From: Flynn, Peggy
Sent: Friday, March 17, 2023 3:37 PM
To: -- City Council
Cc: Bolt, Christopher; Eichstaedt, Ken
Subject: 3/20 Agenda item 2

Dear Mayor & Councilmembers—a councilmember suggested class 3 bike lane markings for the Garfield pavement restoration project (agenda item 2). Staff response below:

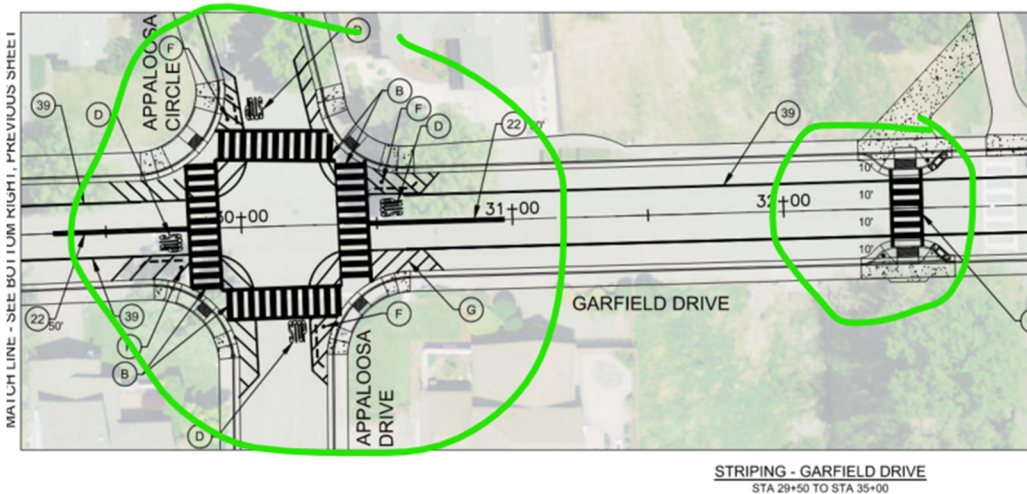
Better than Class 3 bicycle facilities are the defacto Class 2 bike lanes. We discussed options internally on this. The 40 ft. width allows the travel lanes to be narrowed to 10 ft. in each direction to help slow traffic. The outside edge line maintains a 10 ft. shoulder, that given the lack of vehicle parking used, will be accessed for bike travel. NOTE: To formally be classified as a Class 3 facility, sharrows can be added to the inside 10 ft. lanes.

See screenshot below for intersection improvements and striping leading to slower traffic speeds.
